Customer	: CU-DAR001 Dart Helicopters Services	Drawing Name	: 350 SKIDTUBE ASSEMBLY LH
Job Number	: 39969	Part Number	: D350636011 <i>PER DSI</i>
Estimate Number	: 10262	Drawing Number	: D2750 UNDER REVIEW <i>9413</i>
P.O. Number	:	Project Number	: N/A
This Issue	: 19/06/2008 S.O. No. :	Drawing Revision	: E
Prsht Rev.	: NC	Material	:
First Issue	: // Type : SKIDTUBES	Due Date	: 05/07/2008 Qty: 1 Um: Each
Previous Run	: 39657		
Written By	:		
Checked & Approved By	: <i>JUL 08.6.19</i>		
Comment	: Est Rev: I 02.09.25 Rearranged procedure steps KJ Est Rev: J 06-03-23 As per Rev D JLM Est Rev: K 06-07.13 As per dsi9343 EC Est Rev: L 07-07-28 Added SS Wearplates (Rev E) JLM Verified By: EC Est Rev: M 08-04-22 update steps 4, 13 DD verified by: EC

DART SERVICE INSTRUCTION

TO AMEND INSTALLATION INSTRUCTIONS IIN-D350-636 REV E

A	NEW ISSUE	PH	08.05.14
REV.	DESCRIPTION	BY	DATE
DESIGN	PH	DART AEROSPACE USA, INC PORT HADLOCK, WA	
DRAWN	PH		
CHECKED		DRAWING NO.	REV. A
MFG. APPR.	N/A	DSI 9413	SHEET 1 OF 3
APPROVED		TITLE	SCALE
DE APPR.		WEARSHOE MODIFICATION	NTS
DATE	08.05.14	<small>COPYRIGHT © 2008 BY DART AEROSPACE USA, INC THIS DOCUMENT IS PRIVATE AND CONFIDENTIAL AND IS SUPPLIED ON THE E

FIGURE 1 - WEARPLATE MODIFICATION

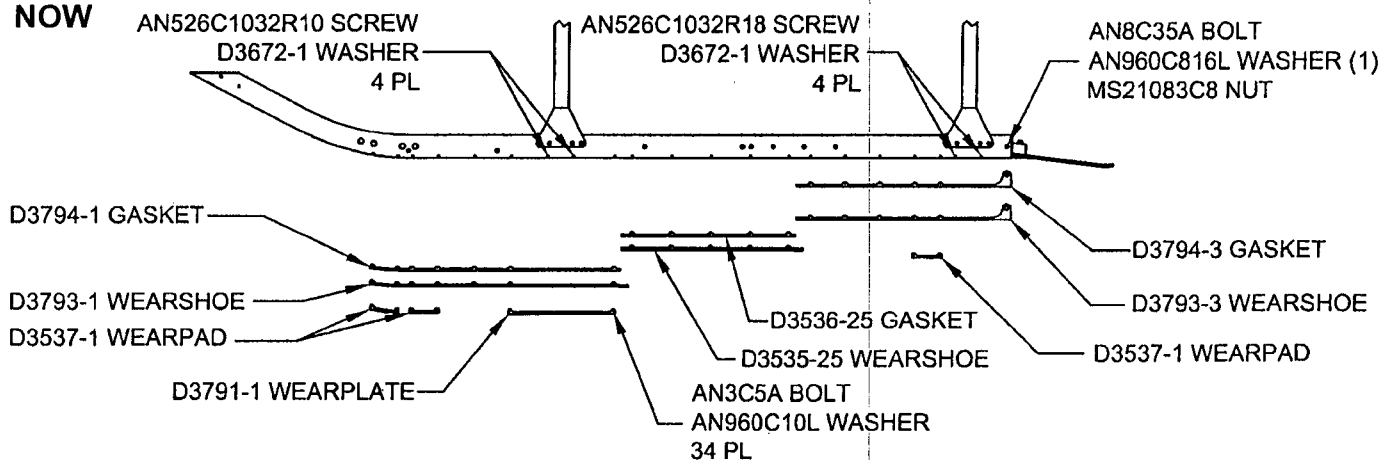
THE WEARPLATES ON D350-636-011/-012/-013/-014 SKIDTUBES AT CHG 004 (AND LATER) HAVE BEEN MODIFIED AS SHOWN IN FIGURE 1 BELOW TO ELIMINATE THE POSSIBILITY OF INTERFERENCE BETWEEN THE WEARPLATES AND CROSSTUBE SADDLES AT INSTALLATION. THERE IS NEGLIGIBLE WEIGHT CHANGE ASSOCIATED WITH THIS MODIFICATION.

(AN526C1032RXX SCREW LOCATIONS NO LONGER USED TO MOUNT WEARSHOES)

TO INSTALL THE DSI 9413-011 KIT, REMOVE THE EXISTING WEARSHOES/GASKETS UNDER THE FWD/AFT SADDLES AND INSTALL NEW WEARSHOES/GASKETS AS SHOWN IN FIGURE 1. PLUG UNUSED HOLES WITH AN526C1032RXX SCREWS AND D3672-1 WASHERS. INSTALL SCREWS WITH SIKAFLEX -241/-291 OR PROSEAL 890 OR MIL-S-8802 CLASS 'B2' SEALANT AS SHOWN IN FIGURE 1. NOTE: SOME OF THE PREVIOUSLY INSTALLED HARDWARE IS NO LONGER REQUIRED.
